Assembly Alert: 146

Subject: 1" Push Pull Tube (KPCS0146)

Models Effected: S-17 Stinger

| ITEM NO. | DESCRIPTION | FINISH: | DATE | REV. |
|--|--------------------------|--|----------|------|
| FRACTIONS ± 1/16 | | DWG. NO. KPCS0146 | | |

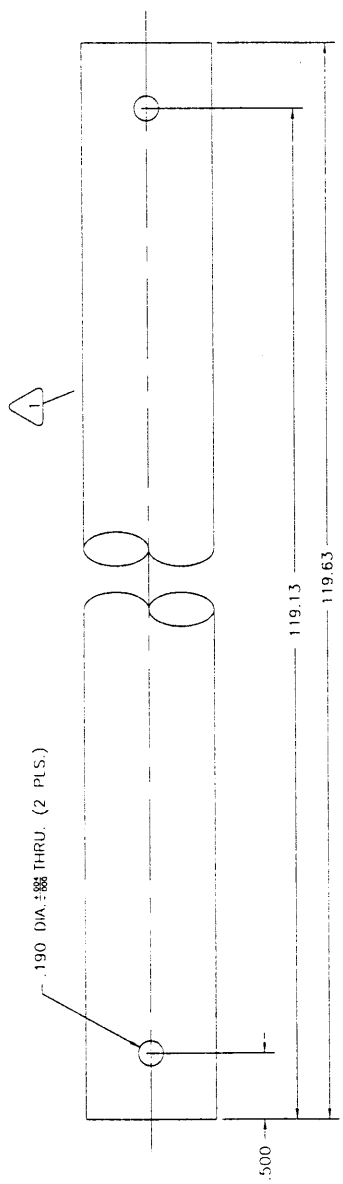
The 1" elevator push pull tube (KPCS0146) provided in the Kit, may prove to be too long to obtain adequate travel range. Figure one shows lengths of the KPCS0146. Please adjust if required.

| REVISIONS | |
|-----------|--|
| A | WAS 122.000, 122.50 IS 120.000, 120.50 PER DCR 3304 R.C.H. |
| B | WAS 120.000, IS 119.125, WAS 120.50, IS 119.63 PER DCR NO 3609 |
